Access Compliance Report Public Rights-of-Way (Curb Ramps)

Main Street: KOOTENAY_DR Cross Street: RAINIER_DR Location: SE

ADA ID: RPAT211001100838 Ramp Type: Type 6 - Directional 1 Initial Pass/Fail: Fail Overall Compliance: No Severity Score: 2

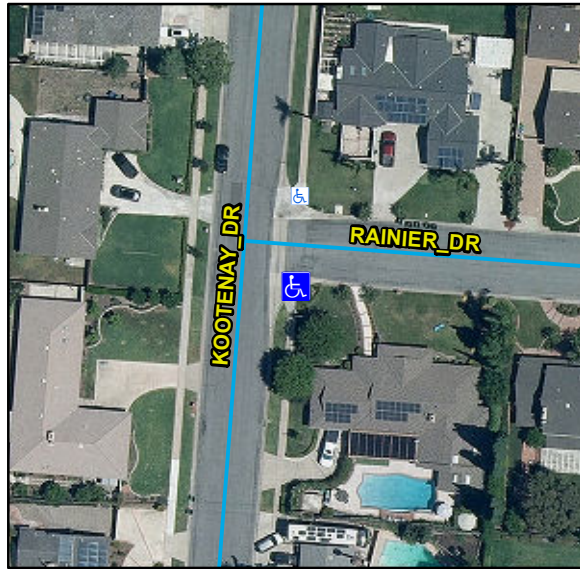
Compliance	Description	Data	Compliance	Description	Data
N/A	Ramp Length (in)	122	N/A	Flare Type LT	
Yes	Ramp Width (in)	48			N/A
Yes	Ramp Run Slope (%)	3.7	N/A	Flare Slope LT (%)	N/A
No	Ramp Cross Slope (%)	3	N/A	Flare Traversable LT	N/A
N/A	Grade Break	N/A	N/A	Flare Type RT	
N/A	Grade Break Slope (%)	N/A			N/A
N/A	Grade Break Cross Slope (%)	N/A	N/A	Flare Slope RT (%)	N/A
	Addl Para Ramp Left?	No	N/A	Flare Traversable RT	N/A
	Addl Para Ramp Right?	No	N/A	DWS Provided	N/A
N/A	Landing Present	N/A	N/A	DWS Contrast	N/A
N/A	Landing Length (in)	N/A	N/A	DWS Length (in)	N/A
N/A	Landing Width (in)	N/A	N/A	DWS Full Width	N/A
N/A	Landing Run Slope (%)	N/A		DWS Offset Type	N/A
N/A	Landing Cross Slope (%)	N/A	N/A	DWS Left Offset (in)	N/A
N/A	Landing Movement Obstructed?	N/A	N/A	DWS Right Offset (in)	N/A
	Landing Movement Type	N/A			
N/A	Landing Shared	N/A			
N/A	Marked Crosswalk 1	No	N/A	Clear Space	N/A
	Crossing 1 Direction	N	N/A	Clear Space To Crosswalk (in)	N/A

Remove & Replace Entire Ramp.

R304.5.3, STD 1115
